Economic and Social Council

Standardization of technical and safety requirements in inland navigation: European Code for Inland Waterways (CEVNI) (Resolution No. 24, revision 5)

Outcome of the twenty-sixth meeting of the CEVNI Expert Group and amendments to the European Code for Inland Waterways

Draft minutes of the twenty-sixth meeting of the CEVNI Expert Group

C. Meaning of sign C.5 (Annex 7)

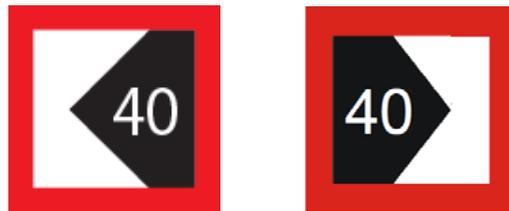
16. The Group decided to amend the description of C.5:

C.5 The channel lies at a distance from the ~~right (left)~~ bank **where the sign is installed**; the figure shown on the sign indicates the distance in metres, measured from the sign, to which vessels should keep
